Project Name:	Land at Bayards, Eastergate (Miller Homes)
Document Reference:	091.5016/SVR/7
Document Name:	SuDS Verification Report – Area 7
Prepared By:	Samuel Flesher
Checked By:	Meagan Weedon
Approved By:	Jon Soar

- 1.1 This Sustainable urban Drainage Strategy (SuDS) Verification Report – Area 7, has been prepared by Paul Basham Associates on behalf of Miller Homes to support the 'As-Built' verification report to Arun District Council in relation to Land at Bayards, Eastergate.

Plot 28

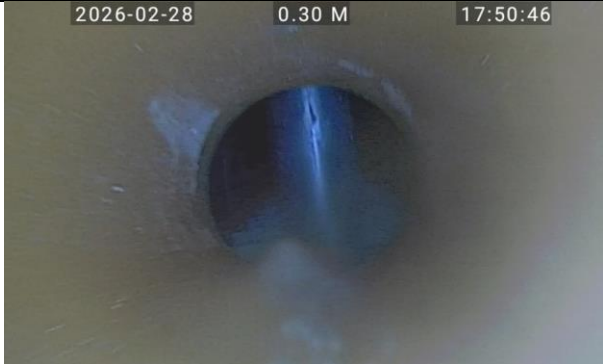
- 4.4 The image provided for Plot 28 shows the infiltration crates to be misaligned and not securely clipped together. The crates appear to be separating and moving away from one another, which is likely attributable to an uneven or inadequately prepared formation surface beneath the crates, which is missing lining. The movement may compromise the stability and performance of the infiltration system and does not appear to be in accordance with the approved installation requirements.

The installed crates appear to be Polystorm Modular Cell units, and it would appear that an insufficient number of units have been installed when compared to the approved design.

The approved proposal specified an attenuation structure measuring approximately 2.0m wide, 4.5m long, and 1.2m deep. However, the photograph provided appears to show only 8 crates installed. Based on the manufacturer's datasheet dimensions of approximately 0.5m wide, 1.0m long, and 0.4m deep per unit, this would provide an approximate storage volume of 1.6m³.

This is significantly less than the 10.8m³ attenuation volume specified within the approved design. As a result, the installed system may not provide the required storage capacity and could increase the risk of surface water flooding to the property.

Furthermore, the second image for Plot 28 shows the infiltration crates completely covered with material. As a result, it has not been possible to visually inspect the pipe connections or confirm whether the correct geotextile membrane has been installed. Consequently, compliance with the approved design and specification for these elements cannot be verified.

- Install additional infiltration crates where the storage volume is less than what was specified in the approved design or provide supporting hydraulic modelling to support the as-built storage.

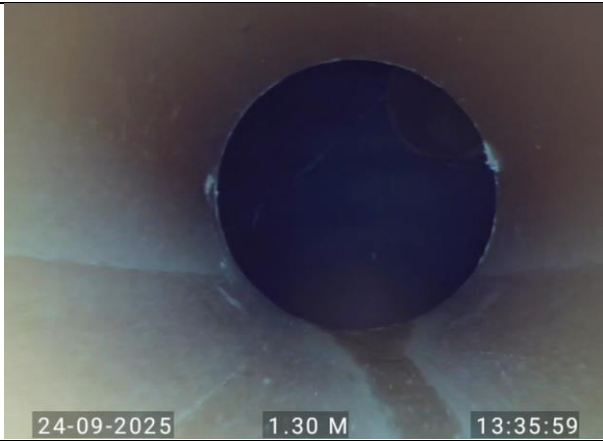
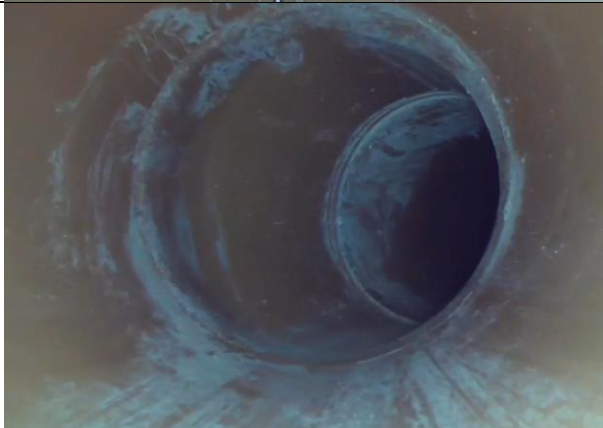
Ref	Defect Images	Comments
PS14-PSCP15		No visible major defects
PSCP15-SA28		Small amount of sediment build up in pipe upstream of infiltration crates
PS77-PSCP75		No visible major defects
PS75-SA29		No visible major defects (2 second video)
PS84-PSCP81		No visible major defects
PSCP81-SA30		Small amount of sediment build up in pipe upstream of infiltration crates
PS93-PSCP92		No visible major defects
PSCP92-SA31		No visible major defects

PS98-PSCP99		PS98-PSCP99 footage looks to be the same as PS93-PSCP92, white spot on left side of the pipe appears in the same place
PSCP99-SA32		No visible major defects
PS106-PSCP337		No visible major defects, footage terminates at bend rather than chamber.
PS337-SA34		Footage is for same pipe as PSCP99-SA32 (recorded 1 minute apart.)

- Once remedial works have been carried out the system will need to be re-CCTV surveyed.
